ADDENDUM NUMBER-1 CONCERNING THE BID REQUEST FOR:

CONCRETE MANHOLE BOXES FOR A FORCE MAIN WATERLINE PROJECT

5/18/18

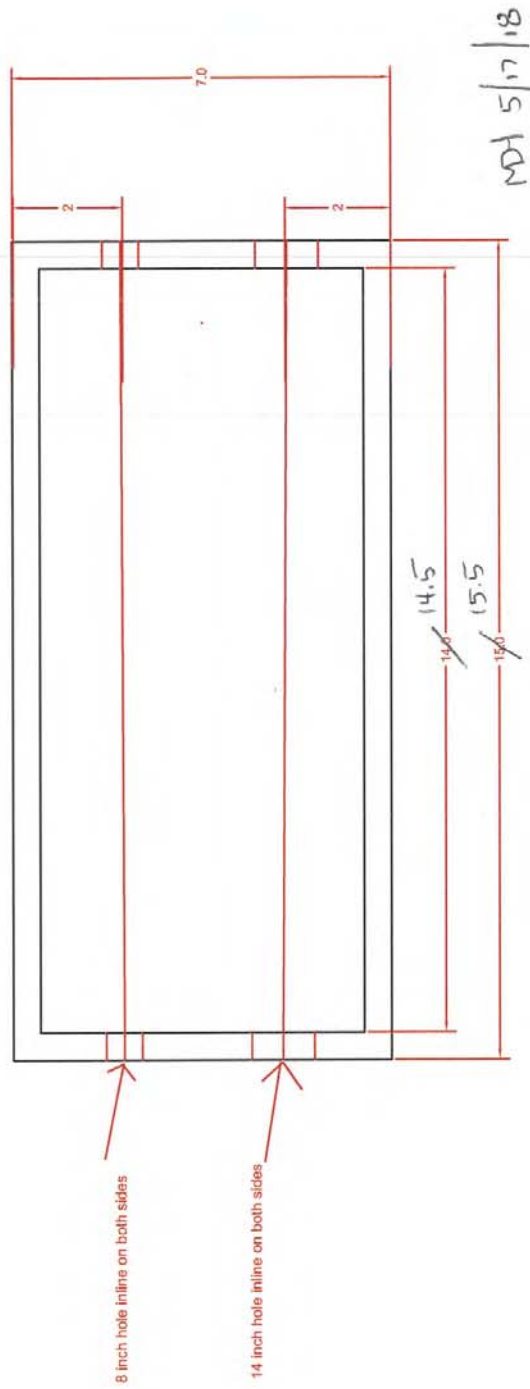
Pages-14 thru 16, within Exhibit A (Product Drawings) as attached on pages-4, 5, and 6 of this document.

Top View of BOX

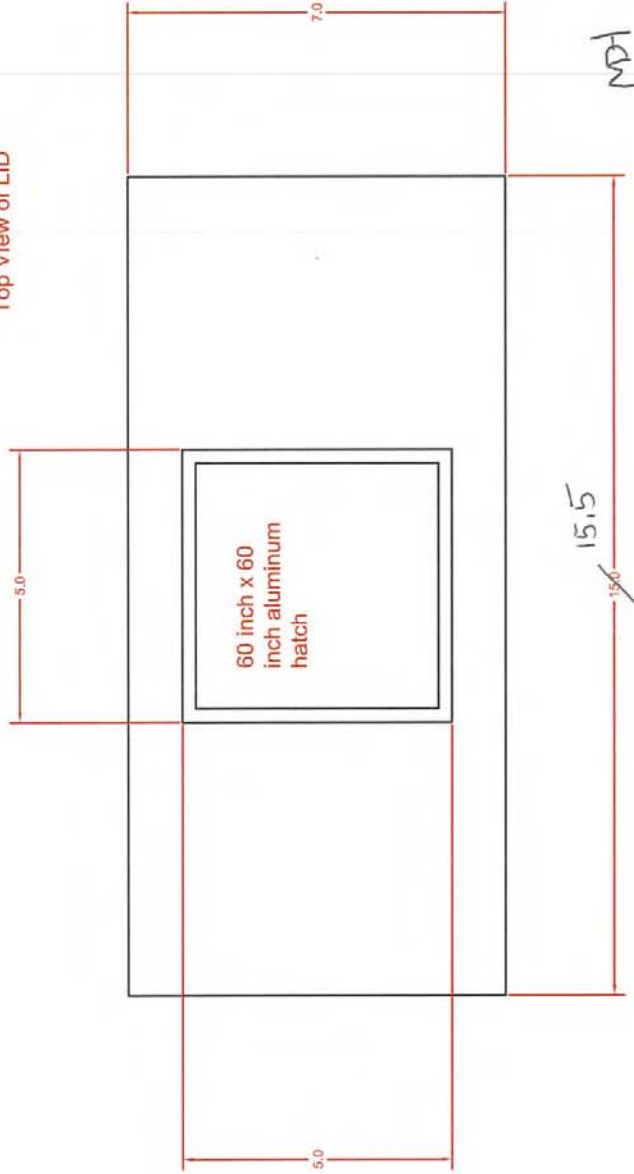
Dimensions: Supply six new concrete manhole boxes approximately 7 feet wide by **15.5 feet long** by 9 feet tall; see attached drawings for details as listed with Exhibit A on pages-14 thru 16. The thickness of the walls, top cover and bottom flooring for these concrete boxes is required to be a minimum of 6 inches. The concrete box walls should be constructed in two parts, with the seam along the center line of two sets of holes in the narrow side walls. This design will be used to facilitate installation of piping during construction. After installation, the pipes will be grouted in place on the exterior of the box to form trust blocks. The Concrete Manhole Box drawings were simplified to show the dimensions and do not show the required Lifting Lug System and reinforcement bars. Number-5 reinforcement bars are required to be installed on 12 inch centers as near to the center of the top, bottom and side walls as possible. Each Concrete Manhole Box is required to be manufactured with Portland cement: ASTM C150 Type I or Type II. The County will only purchase boxes that have no deep cracks, splits, chips and/or large holes and are free from dirt, garbage and any other types of debris; these boxes must also be squared and level for installation purposes. The County reserves the right to reject any and or all Concrete Manhole Boxes that do not meet these bid specifications.
